Service Advisory

CC-681

Subject: **759-04277 Service Kit Replacement For 617-04036 and 617-04037 Bevel Gears and 718-04269 Steering Cam.**

FIGURE 1

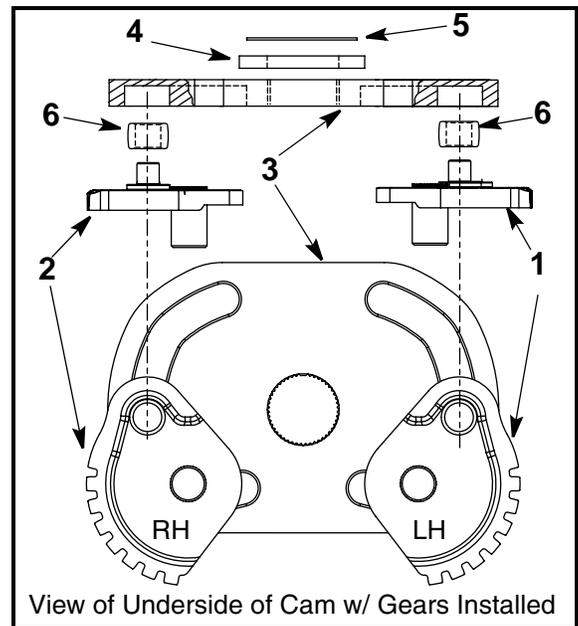
PURPOSE: This service kit provides the latest production RH and LH bevel gear assemblies, steering cam (Hydro) and necessary hardware when replacing either the 617-04036 LH Bevel Gear or 617-04037 RH Bevel Gear or the 718-04269 steering cam, which are no-longer-available, in the 618-04634 or 618-04430 steering gearboxes. If only one of the bevel gears or the steering cam are damaged, both new bevel gears, the new steering cam and hardware supplied must be replaced as a complete set. This kit is only applicable to iSeries riders with hydrostatic transmissions.

ITEM NO.	PART NUMBER	QTY	DESCRIPTION
1	617-04047	1	GEAR ASM:BEVEL:STEERING:LH:27T
2	617-04048	1	GEAR ASM:BEVEL:STEERING:RH:27T
3	718-04644	1	CAM:STEERING:HYDRO
4	736-0274	1	WASHER:FLAT: 1.01 x 1.750 x .172
5	736-0615	1	WASHER:THRUST: .793 x 1.368 x .015
6	741-04204	2	BEARING:SLEEVE: .437 DIA. x .3425 LG.
7	*	1	THIS INSTRUCTION SHEET
